HASTINGS PLANNING COMMISSION COMMUNICATION

SUBJECT: Information – March 3, 2025 Planning Commission Meeting.

Subject: Bachman Fields PUD

Request: Preliminary Development Plan Review – of the proposed development of 121 single-family residential site condominium units on 38 acres as a planned unit development

PLANNED UNIT DEVELOPMENT
SITE DEVELOPMENT & NATURAL FEATURES PLAN
BACHMAN FIELDS

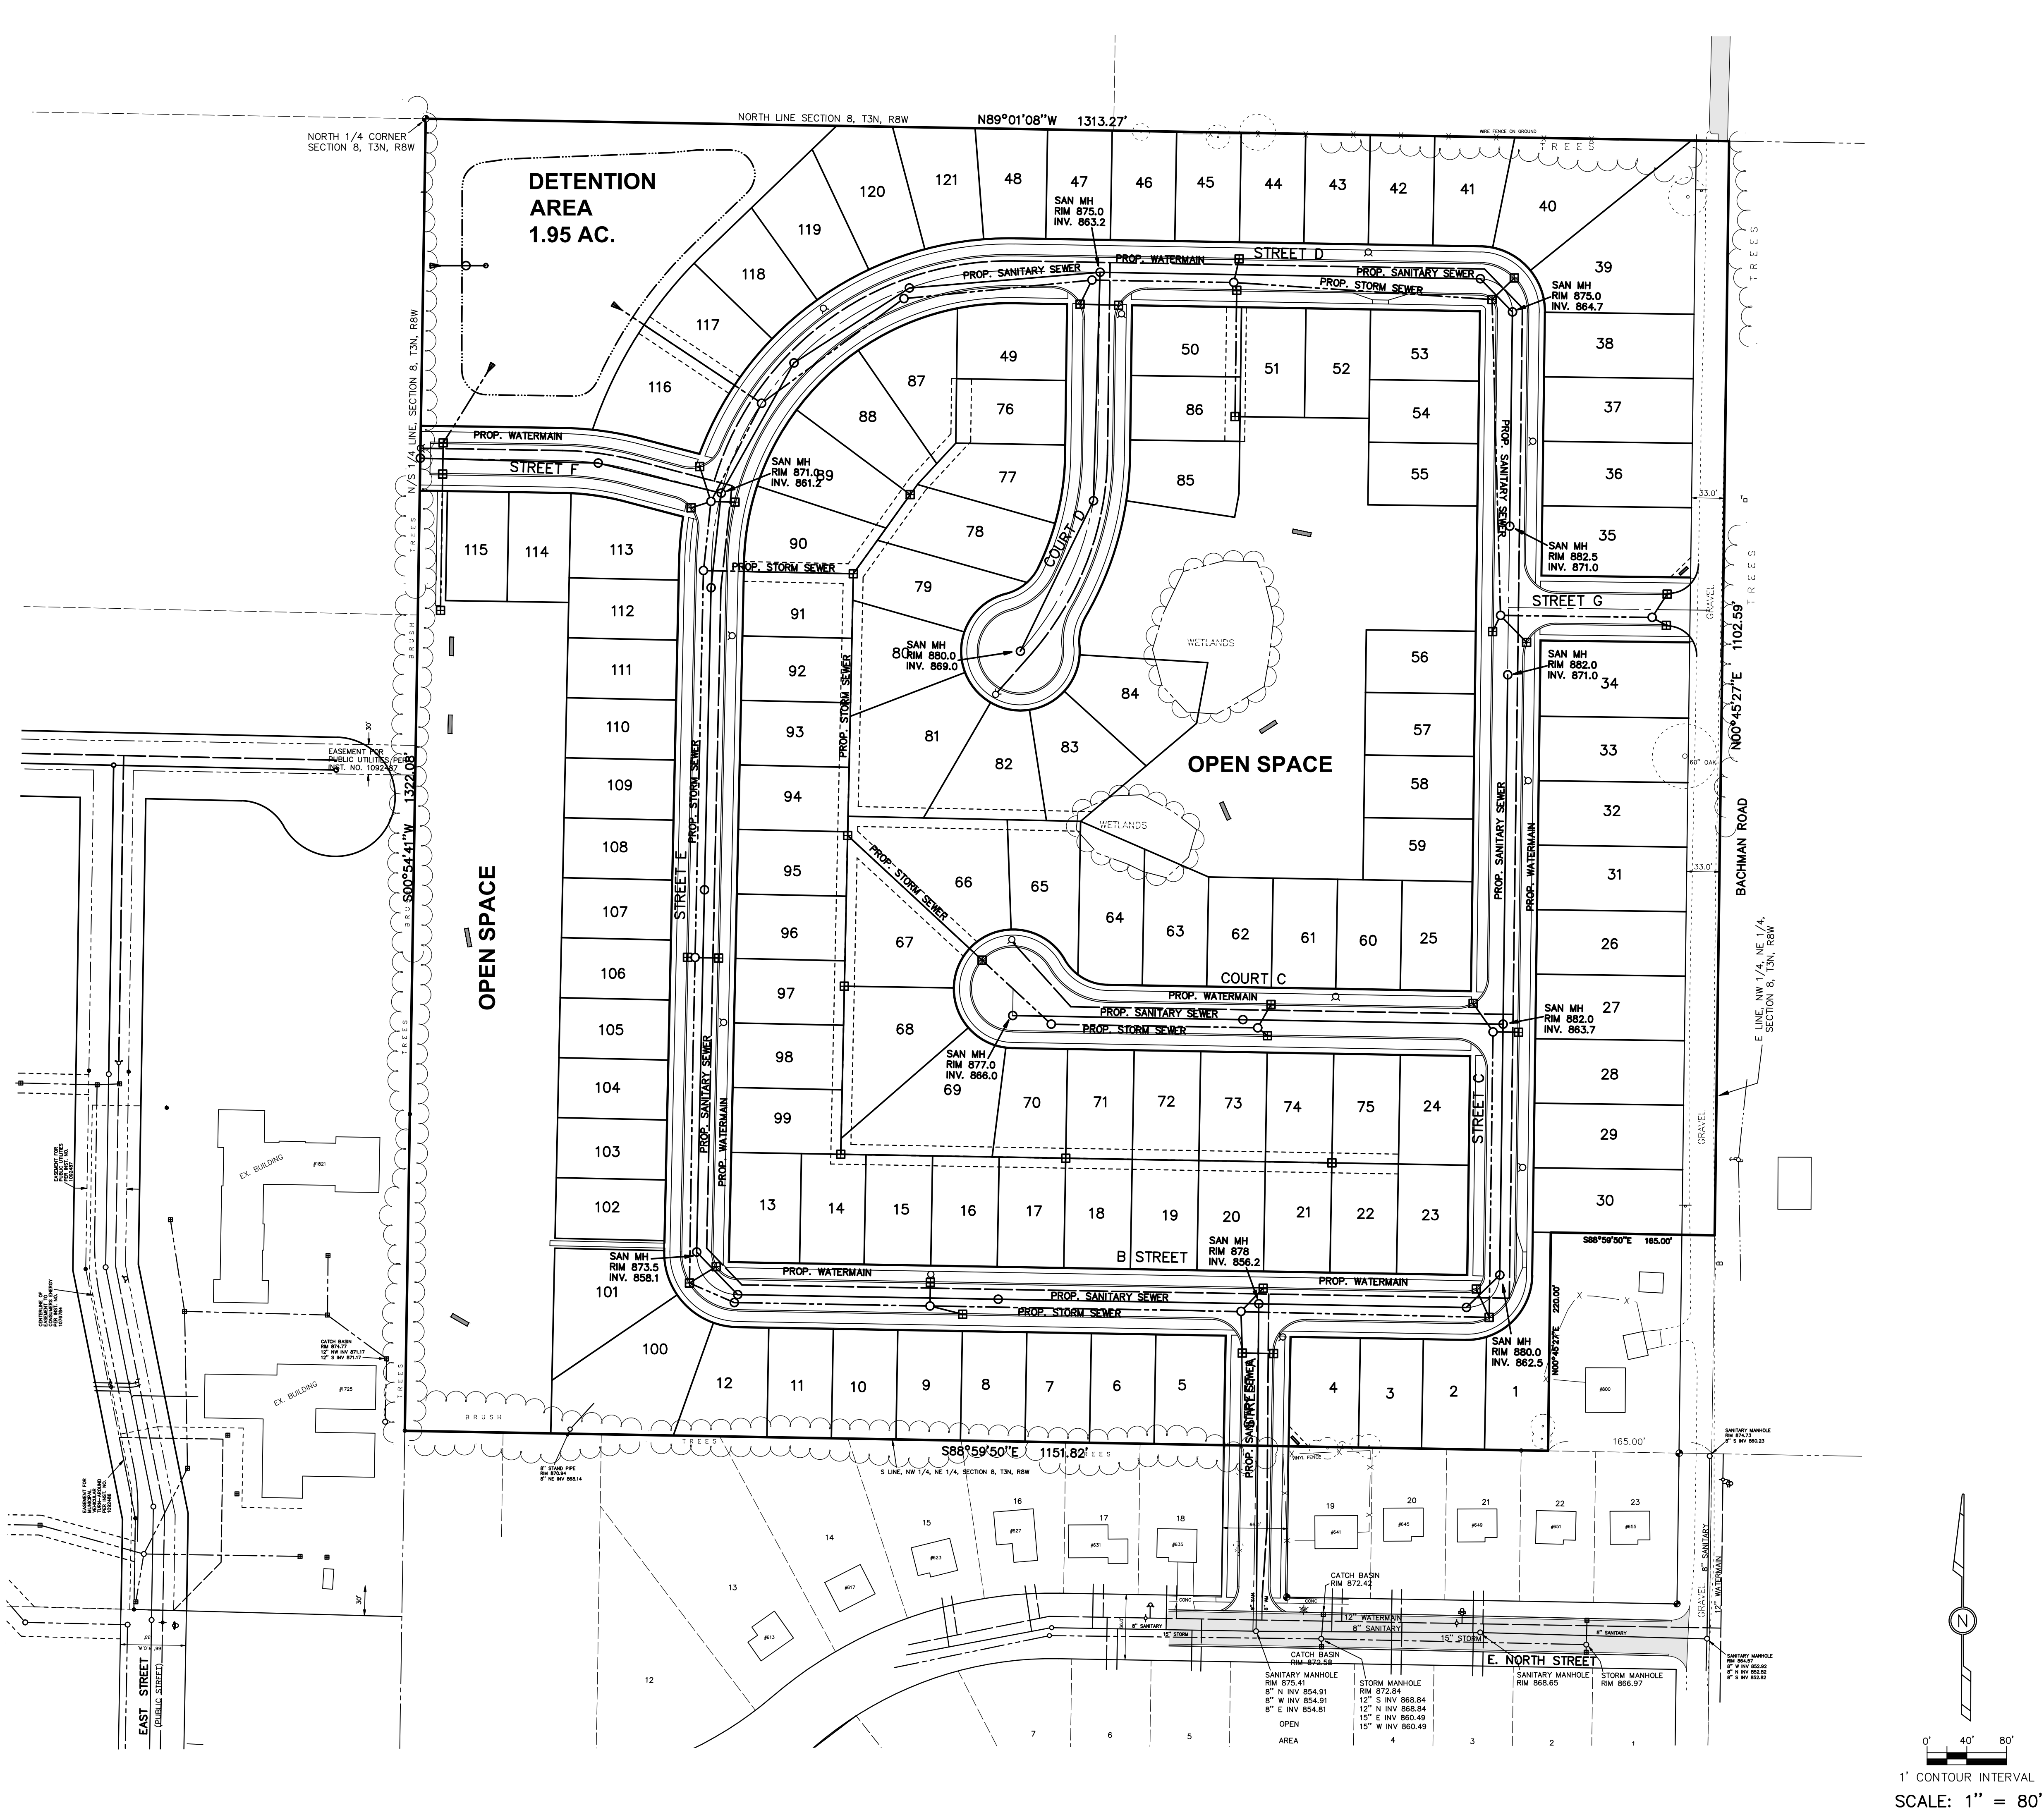
1. The site condominium preliminary plan submittal is lacking the following:
 - required cover sheet
 - survey plan (signed/sealed by site surveyor)
 - location, nature and size of all common elements

- draft master deed noting location, description, use/occupancy and maintenance provisions for all general and limited common elements
2. The site condominium preliminary plan does not meet the Site Development Requirements of the R1-A District . . and has instead been designed to meet the requirements for an Open Space Neighborhood.

3. The Open Space Neighborhood approach is designed to allow more lots than otherwise possible under conventional development . . essentially in exchange for the preservation of ‘meaningful’ open space within the development. To that end, it is important that the open space plan be designed consistent with the open space requirements of the OSN. – *see review comments*.

4. The utility plan, street plan, and stormwater management plan shall be subject to City review/approval.

- 8) The project plan does not reflect compliance with the Site Development Standards of the R1-A District.**
